T10/05-106 revision 1

To: T10 Committee (SCSI)

Subject: SAS 1.1 - Link and Port layer state machine fixes

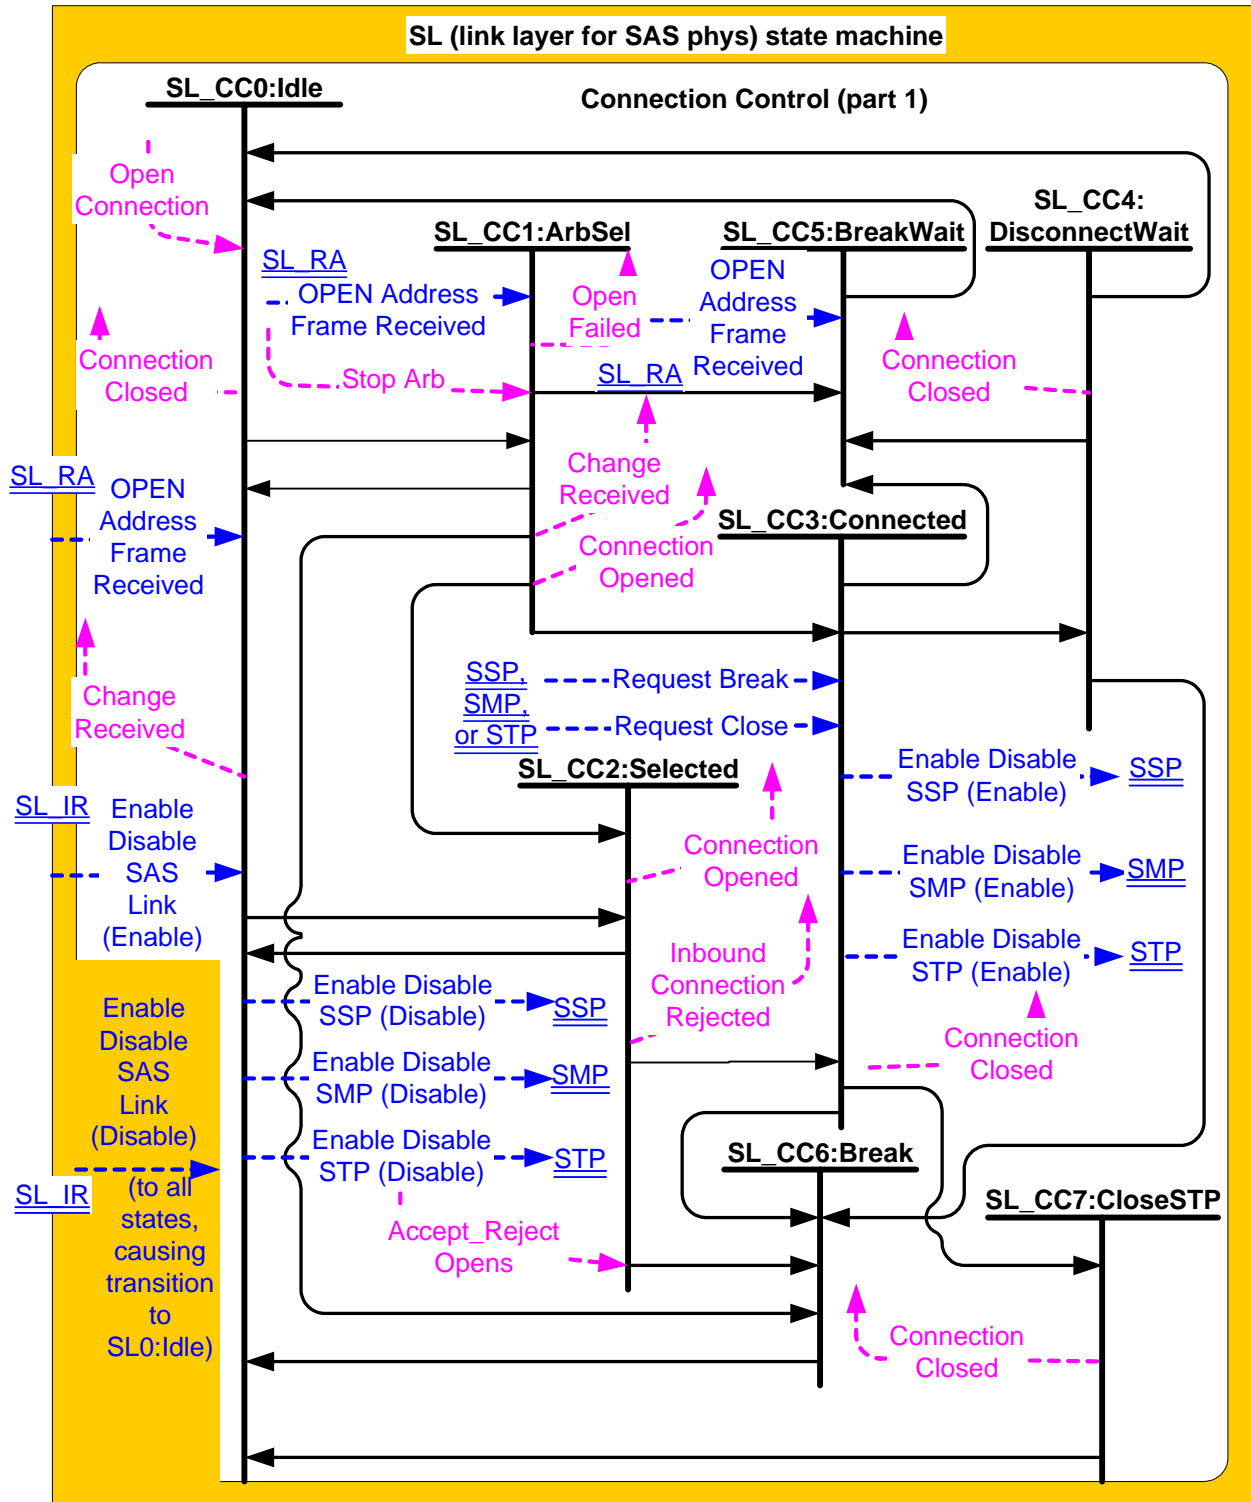
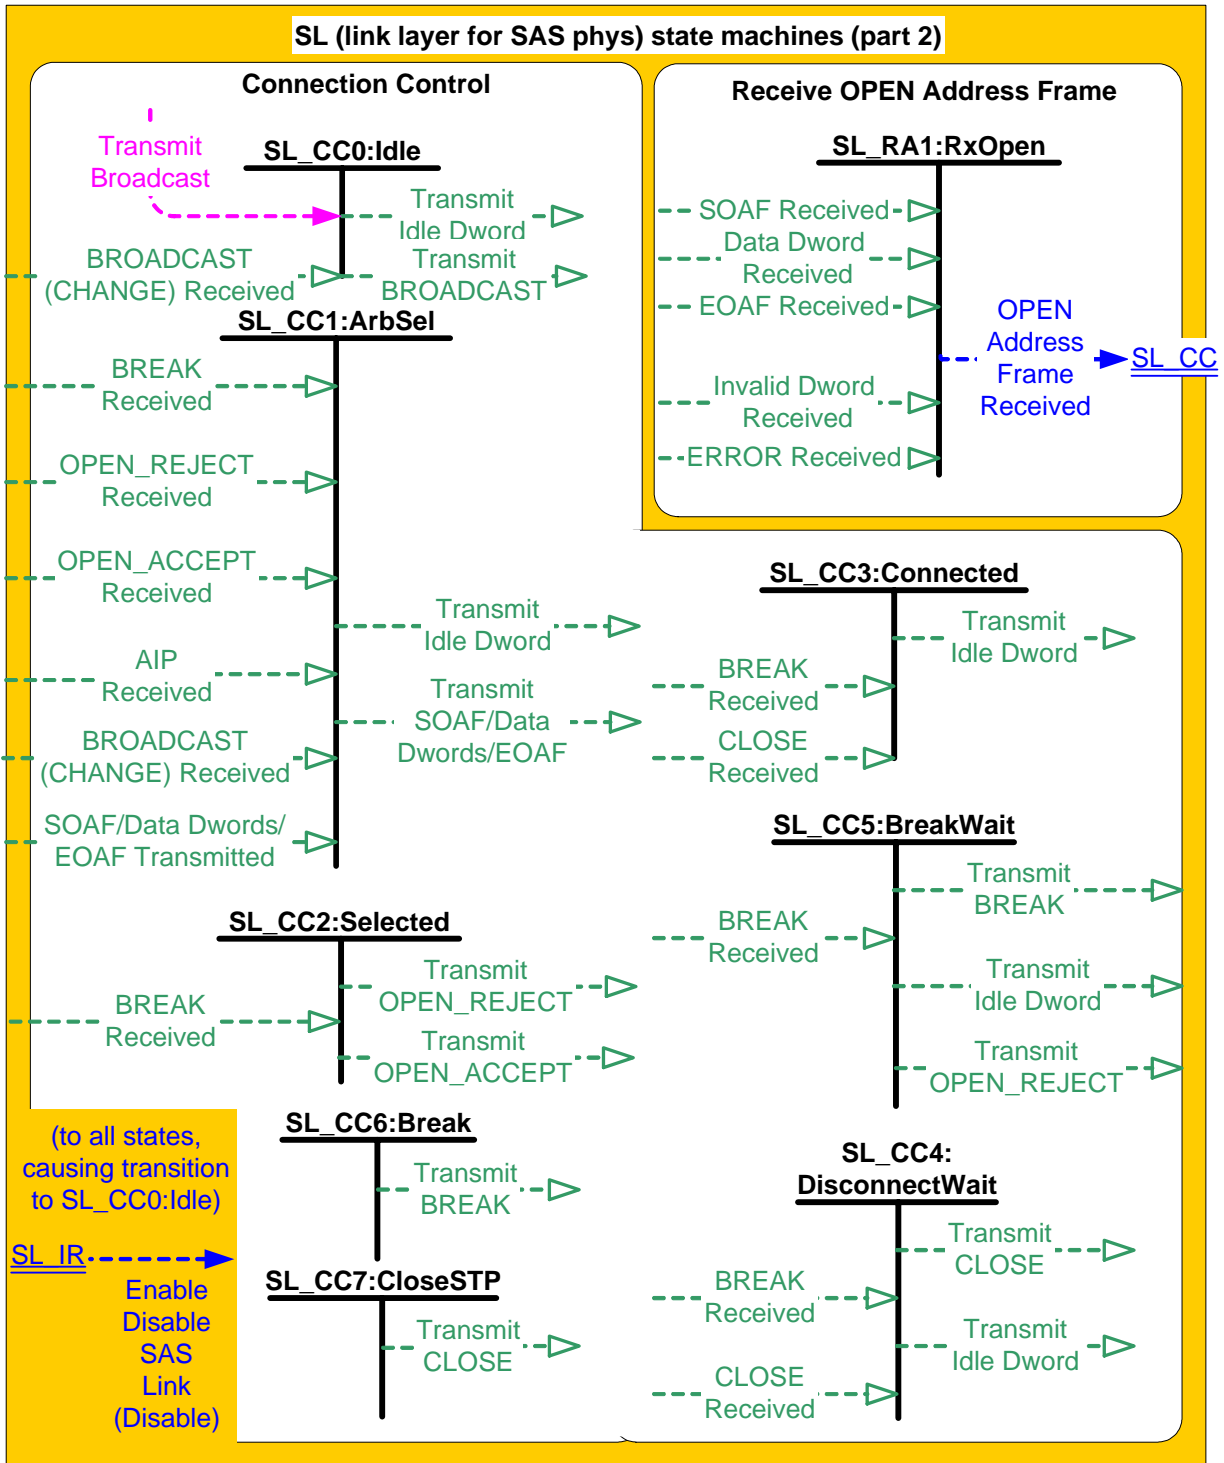
- In the SL_CC5:BreakWait state there is a Connection Closed confirmation shown in the state machine figure but there is no description in the text as to when to send it or which Connection Closed it.
- In the SL_CC2:Selected state there is an Inbound Connection Reject confirmation that is not shown in the port layer state machines.
- There is a period of time when the PL_PM state could send an Open Connection request that would be ignored because the SL state machine is not in SL_CC0:Idle. The result of this would be that PL_PM would hang in the PL_PM2:Req_Wait state. This is most likely to occur as the result of sending or receiving a BREAK.

The solution to these problems is to add a new argument to the Connection Closed confirmation in the SL_CC6:Break and SL_CC5:BreakWait states that would indicate that a Transition to Idle occurred as a result of a BREAK primitive. This would cause the PL_PM states to transition to PL_PM1:Idle thereby removing the hang.

Change figure 126 to add in a Connection Closed confirmation exiting from the SL_CC0:Idle state. Delete the Connection Closed confirmation from the SL_CC5:BreakWait.

- b) [an Enable Disable SMP \(Disable\) message to the SMP link layer state machine;](#)
- c) ~~and Enable Disable STP (Disable) messages to the SSP, SMP, and STP link layer state machines;~~
[and](#)
- d) [a Connection Closed \(Transition to Idle\) confirmation to the port layer.](#)

Figure 1 — PL_PM (port layer phy manager) state machine (part 1)

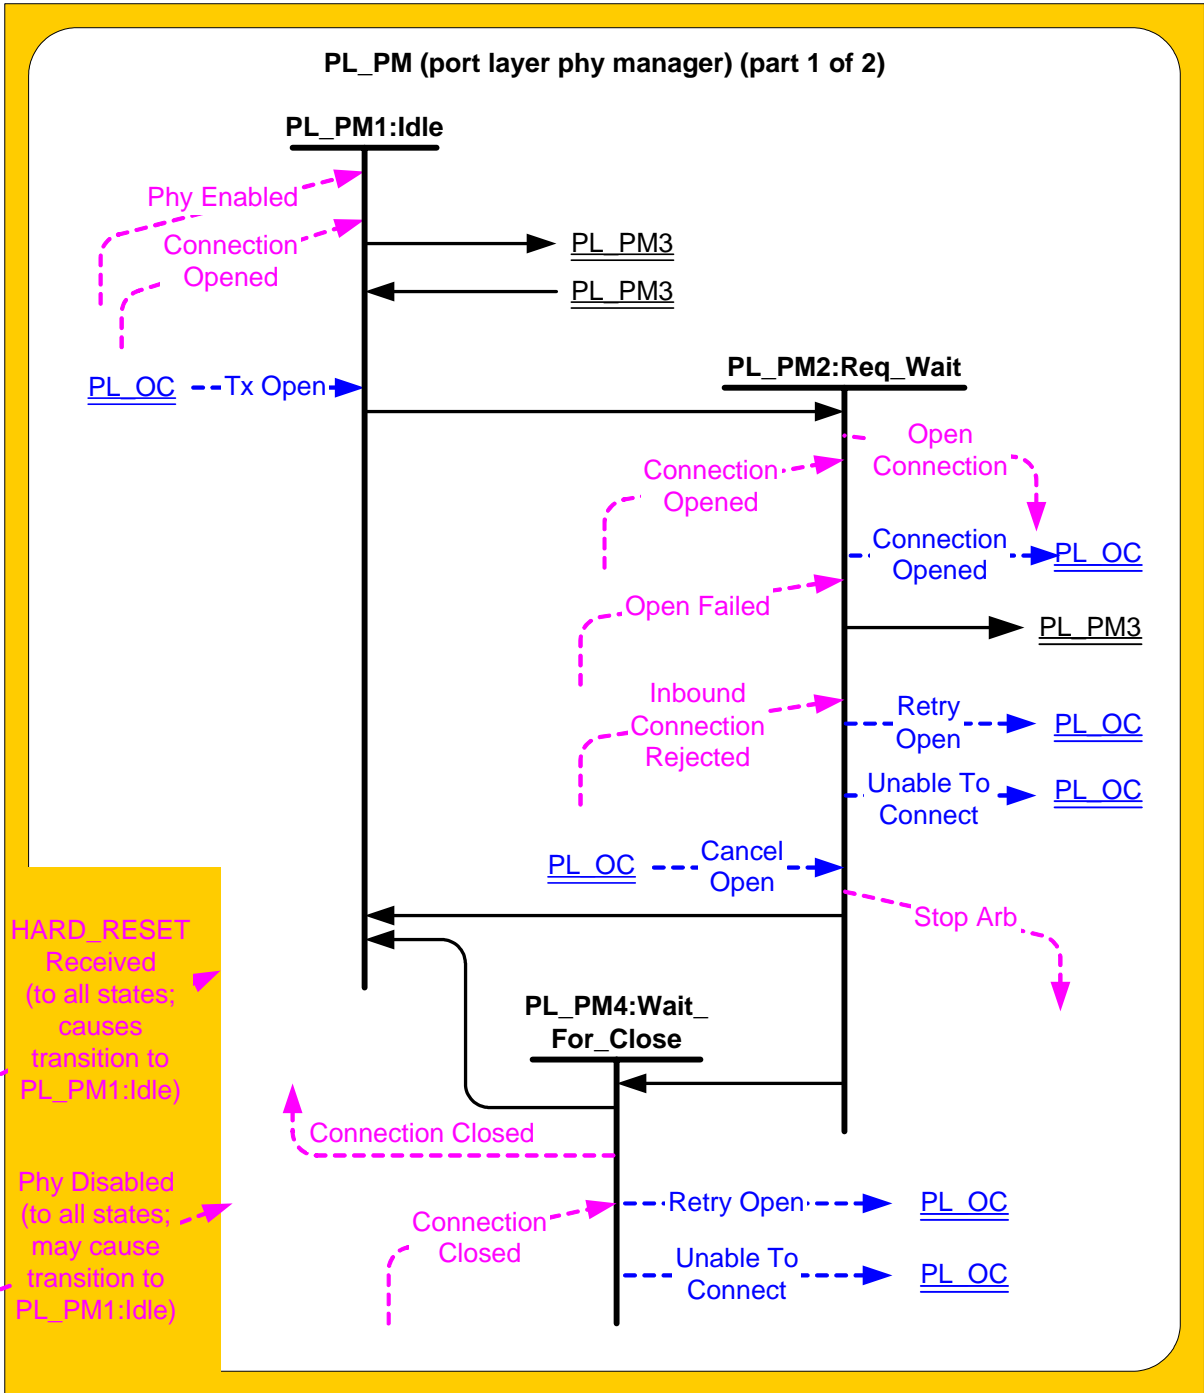
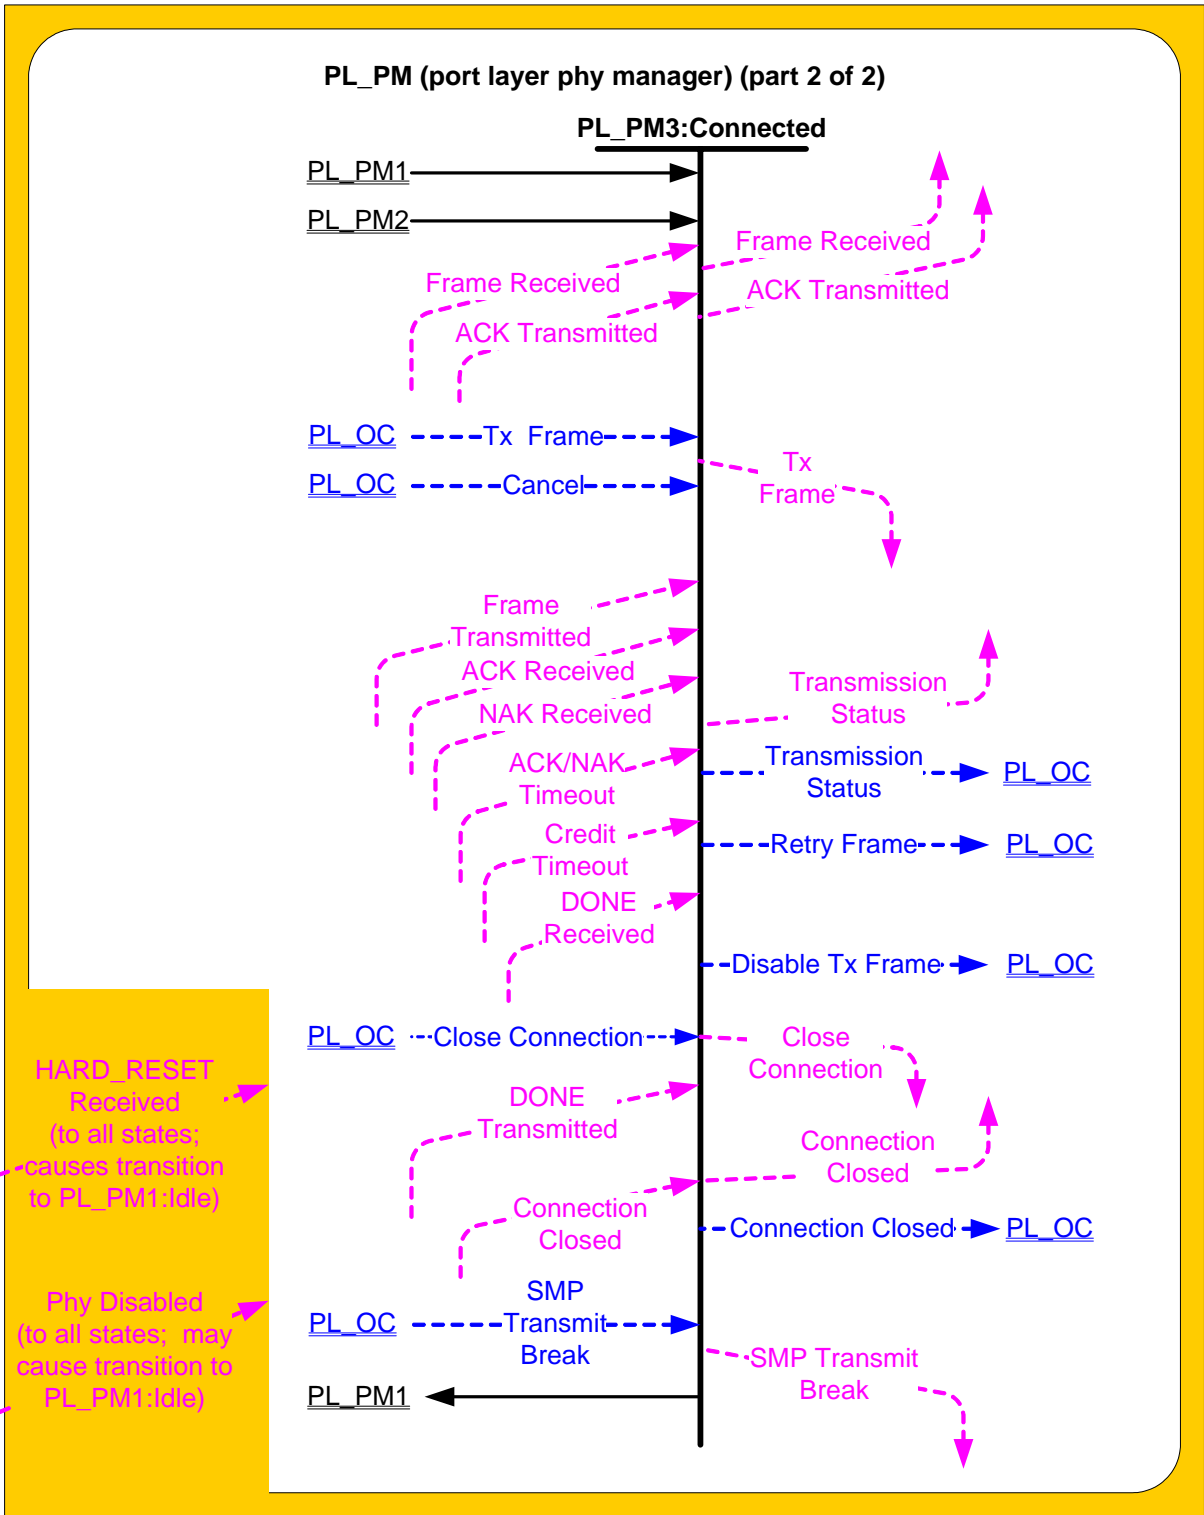
Add to figure 147 an Inbound Connection Rejection confirmation going to the PL_PM2:Req_Wait state. As shown in the figure below.

If this state receives an Inbound Connection Rejected confirmation after sending an Open Connection request, then this state shall discard the Open Connection request and send a Retry Open (Collided) message to the PL_OC state machine.

- a) an Open Failed (Open Timeout Occurred)
- b) [an Open Failed \(Break Received\); or](#)
- c) an Open Failed (Port Layer Request).
